SEWAGE DISPOSAL SYSTEM

MARYLAND STATE DEPARTMENT OF HEALTH

LOCATION SURVEY
 14160 FORSYTHE ROAD
 4TH ELECTION DISTRICT
 HOWARD COUNTY MD

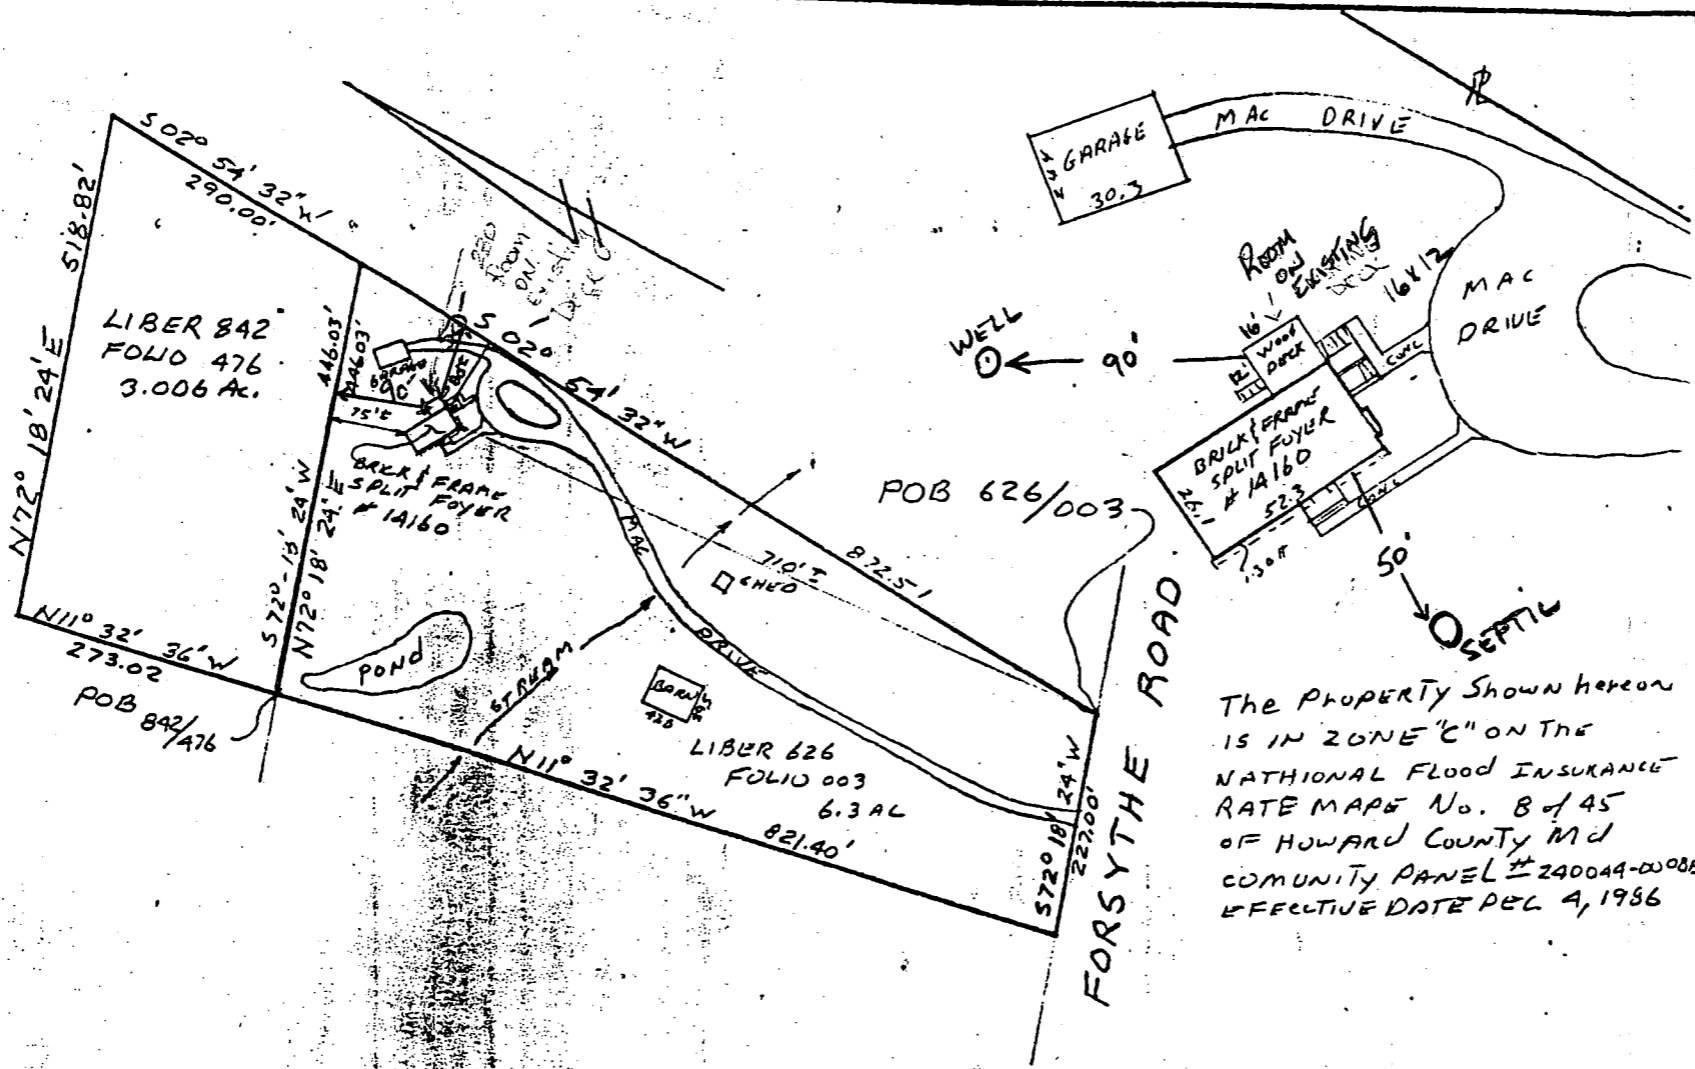
REMARKS Trench needed 11' deep 1 1/2" 3 to 4' below grade 15' long
12/16/95 4:10 P.M. Contacted Bob Lindstrom by phone
12/22/95 10:30 Am. Spoke to Pat Lindstrom. Ok to fill trench
with stone and backfill
